**From:** [John Bolecek](#)  
**To:** [Onufer, Kathleen M. - PDR](#)  
**Subject:** UDC comments  
**Date:** Wednesday, June 08, 2016 9:01:58 PM  
**Attachments:** [14thfranklin.pdf](#)

Item 2: Please ensure the standard curb ramp design is 2 per corner (1 per each direction of crossing). See the attached PDF on how to modify the proposed design.

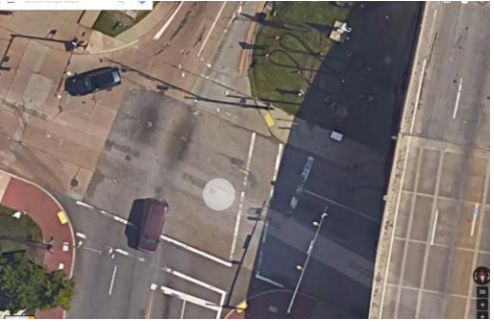
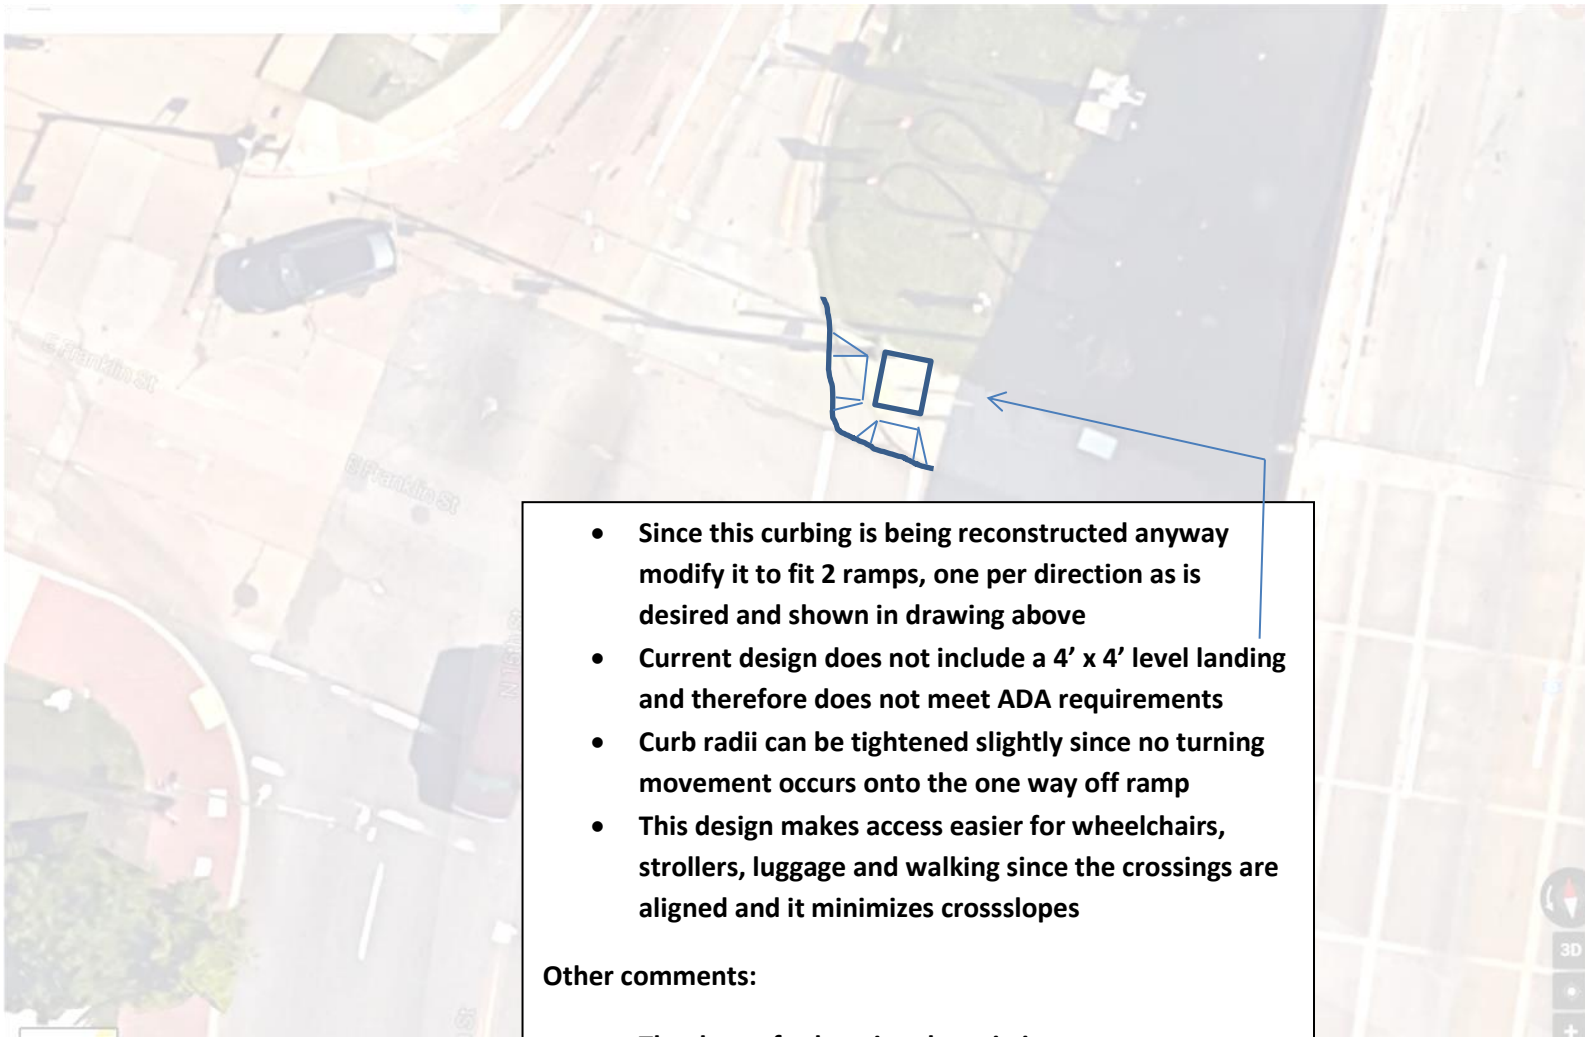
- **Since this curbing is being reconstructed anyway modify it to fit 2 ramps, one per direction as is desired and shown in drawing above**
- **Current design does not include a 4' x 4' level landing and therefore does not meet ADA requirements**
- **Curb radii can be tightened slightly since no turning movement occurs onto the one way off ramp**
- **This design makes access easier for wheelchairs, strollers, luggage and walking since the crossings are aligned and it minimizes crosslopes**
